**P99-063 Main Avenue Warehouses**

- REQUEST: A. **Environmental Determination: Negative Declaration;**
- B. **Mitigation Monitoring Plan**
- C. **Plan Review** to construct two warehouses containing 16,200± square feet in one, and 54,000 square feet in the other in the Light Industrial-Review (M-1SR) zone;
- D. **Lot Line Merger** to merge four parcels into two parcels: one containing 1.483± acres, and the other containing 3.578± acres in the Light Industrial- Review (M-1SR) zone.

STAFF EVALUATION: Staff has the following comments:

Exhibit 1B  
Site Plan

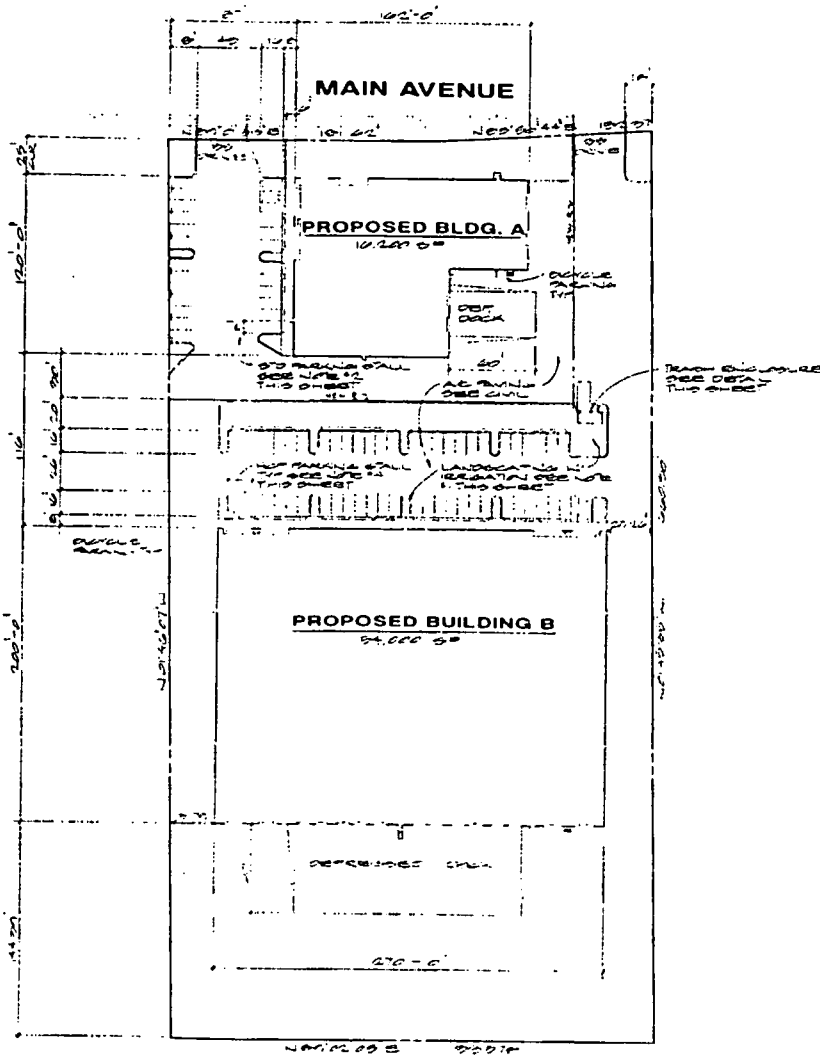
The Zoning Ordinance requires a six foot high masonry wall separating an industrial use from a residential use. The project plans do not show a masonry wall on the west property line to separate the proposed warehouses from the residences to the west. A wall is required along the western property line which abuts the single family residences. No gates are shown on the proposed plan. If gates are to be included a special permit would be required.

The Building Division had no structural comments, but advised that the structure design shall be based on the 1998 California Building Code if the proposed project will be submitted for a building permit on or after July 1, 1999. The Building Division also wants to see that the path of travel from the public street to the proposed building be shown on the site plan.

The two three yard recycle bins are sufficient for the two warehouses, but a reciprocal agreement should be made between the two buildings to use the common trash enclosure.

- C1. Construct a masonry wall along the west property line which abuts single family residences.
- C2. Construct a parapet on all four sides of the building to a minimum of three feet above the roof line.
- C3. Place all mechanical equipment away from the crown of the roof where they could be seen from the street level.

- C7. A reciprocal agreement shall be made between users of the two warehouse buildings to use the one common trash enclosure and the two three cubic yard recycle bins within the trash enclosure.

Exhibit 1C  
Elevations  
Building A

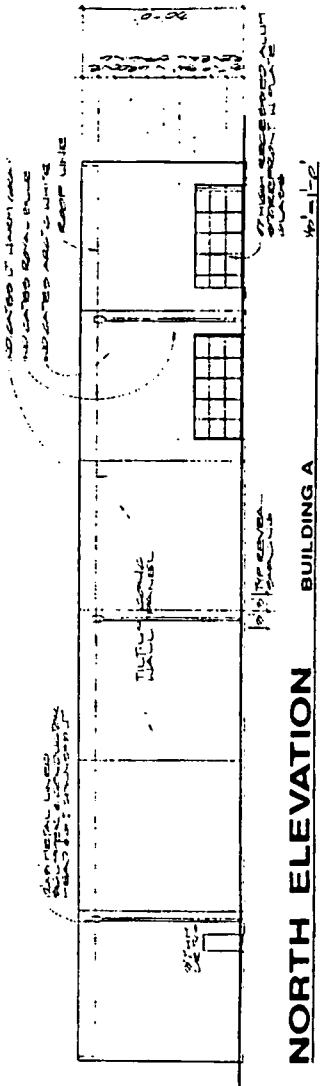
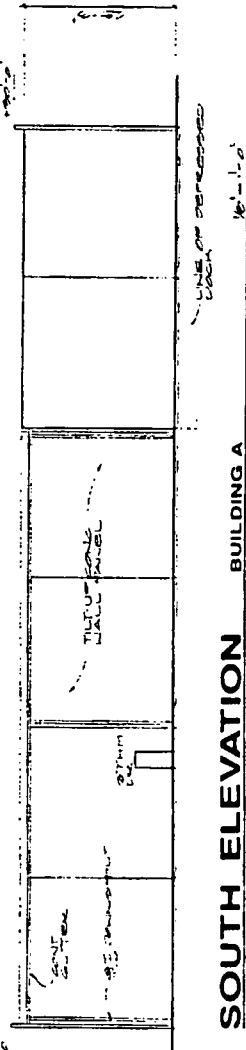
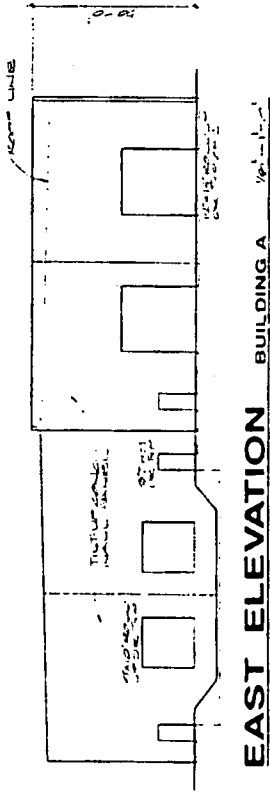
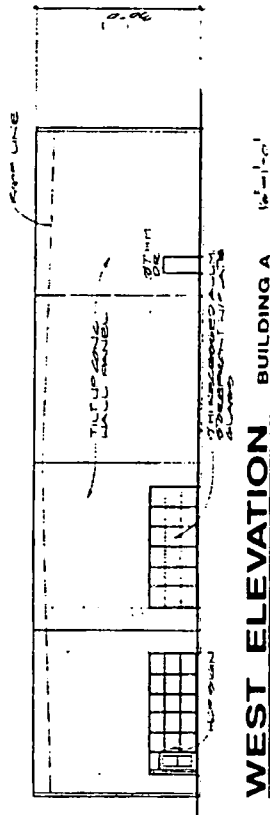
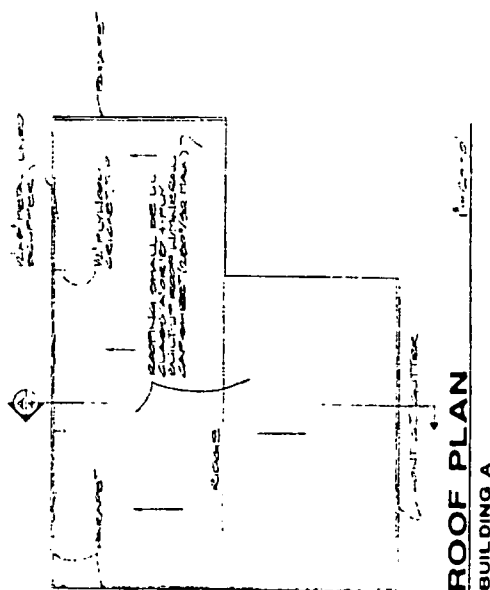
The proposed project would be typical concrete tilt-up warehouses. The height of the proposed buildings would be 30'± feet for Building A, and 31½ feet for Building B. The warehouses would be similar to the other warehouses in the surrounding area. The building plans show the parapet on all four sides of the buildings. The color of the building walls would be light warm gray with royal blue accent panels, and arctic white panels above the plate glass windows on the west elevation of Building A and on the northeast and northwest elevations of Building B. Staff has no issue with the design.

There was concern that the parapets may not be high enough to hide mechanical equipment if the equipment were placed toward the crown of the roof. A condition will be inserted to not allow mechanical equipment at the crown of the buildings where they may be seen from the street level.
